Lot 128
Phase 2
Model Josephine (43-11) Elev A
DANA COOPER and RICHARD COOPER

Colours Upgrade Report
Brooklin Print Date:10-Dec-12

Project Number 09014		
Issued		
1	AUG-12-11	SMH
2	OCT-05-11	LL
Scale 1/8" = 1'-0"		
Client ZANCOR HOMES		
Project OLDE WINCHESTER PHASE 7 WHITBY, ONT		
Model 43-11		
Area (s.f.) C=3387 S.F. INCLUDES FINISHED BASEMENT DOES NOT INCLUDE OPEN TO BELOW		
Lot Coverage (max.)		
Page 2 OF 4

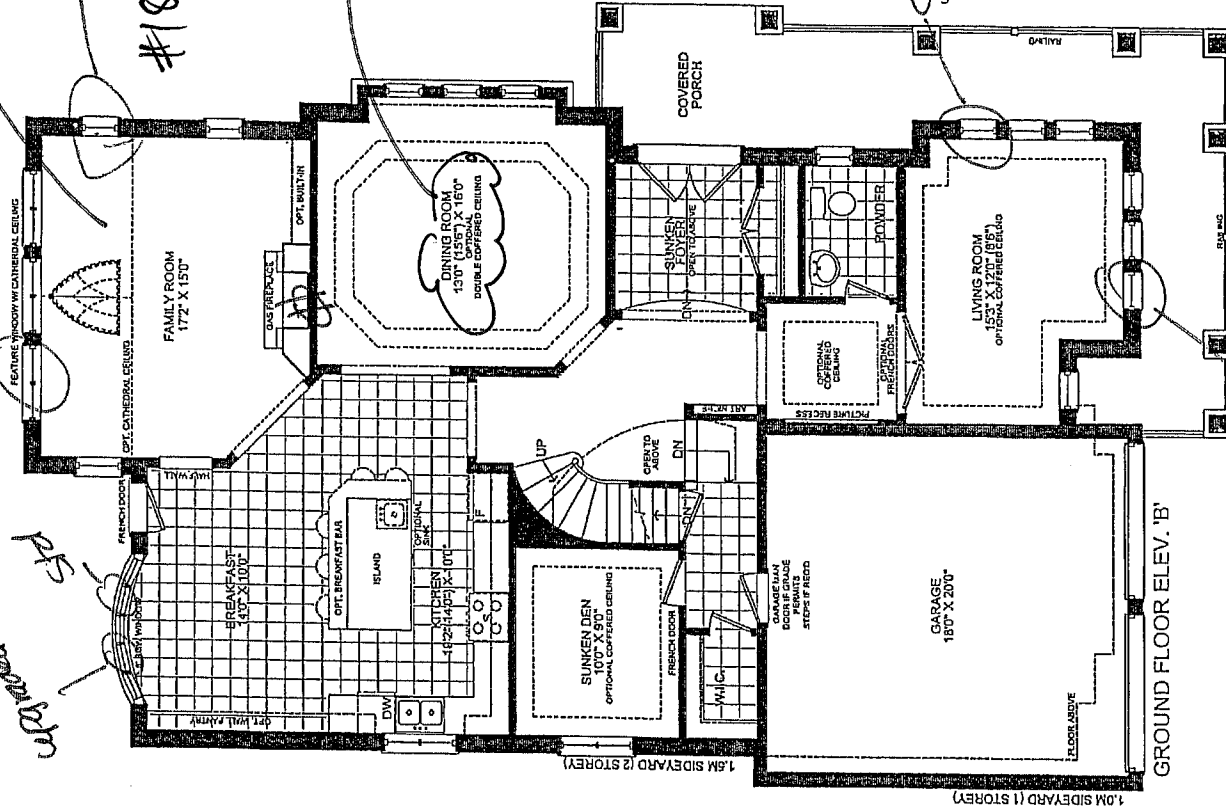
#1824 covered patio.
upgraded

#1832 upgrade

#1826 covered.

#1826 covered patio.
upgraded

SECOND FLOOR ELEV. 'B'
FLOOR AREA: 1827 S.F.
DEDUCT D.I.R.: 82 S.F.
TOTAL: 1745 S.F.

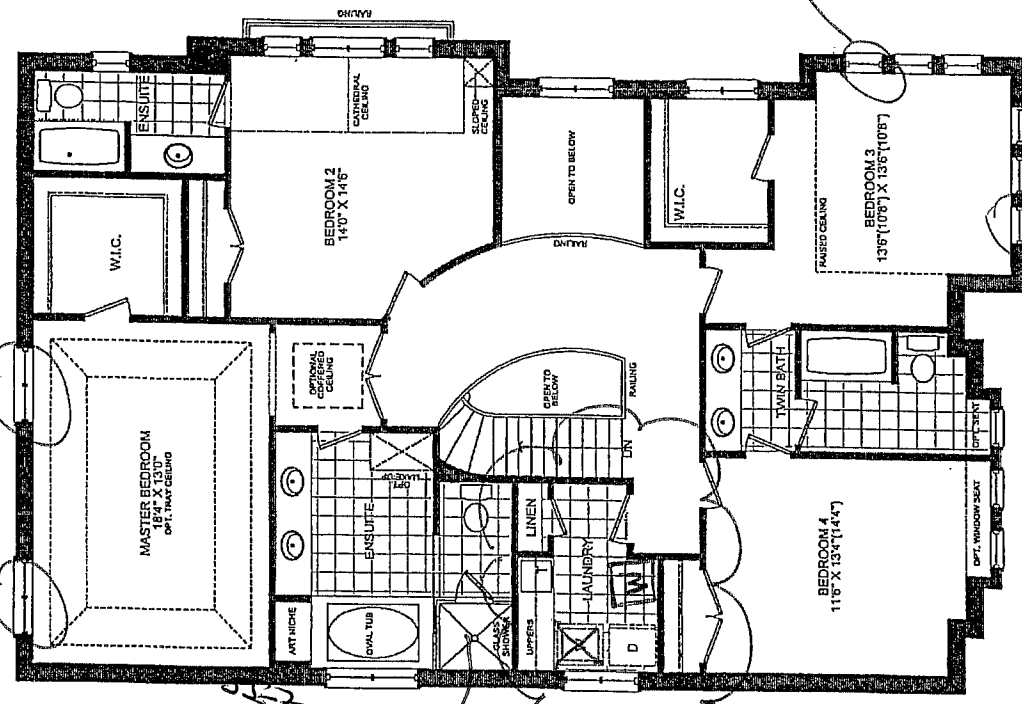
Stl operable
upgraded operable

Stl operable

upgraded operable

#1827
#1827

#1819
Washer/dryer
location change.

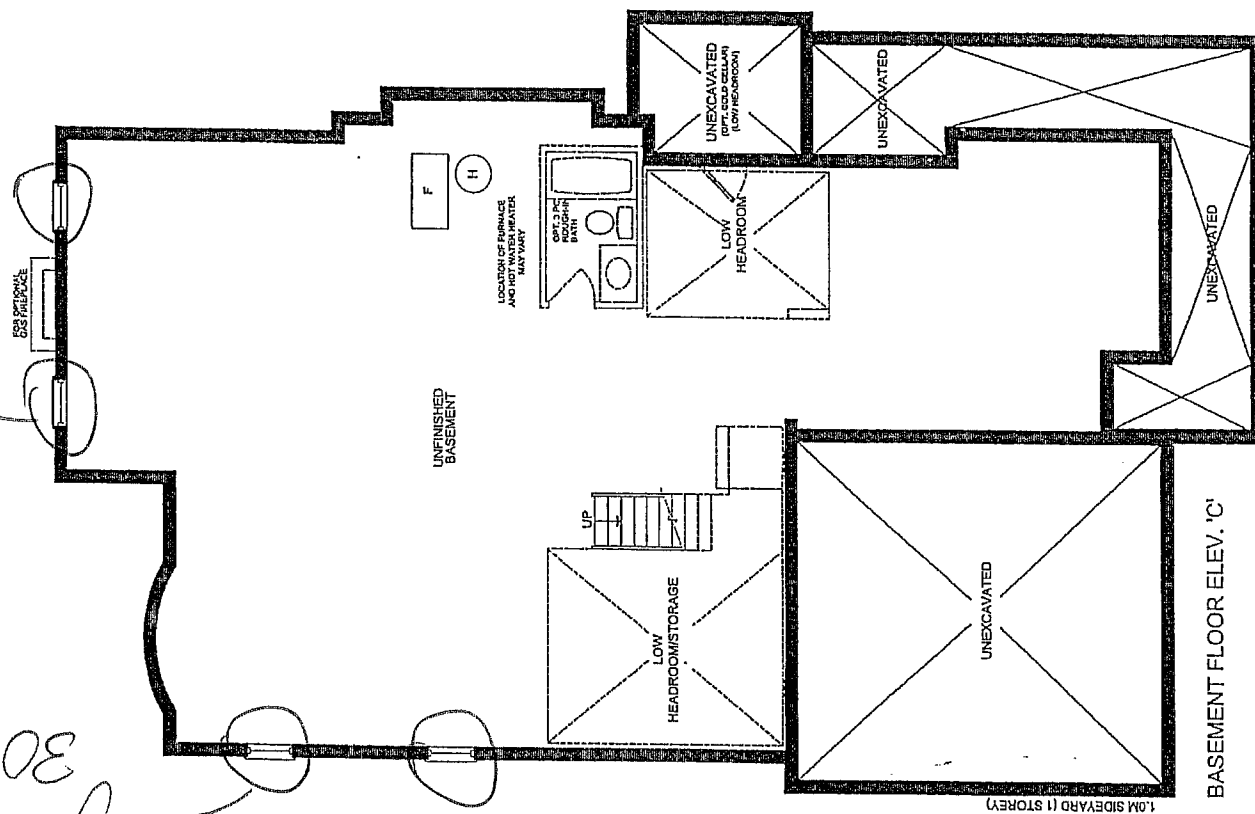
#1823
larger
 30×24

#1823
larger
 30×24
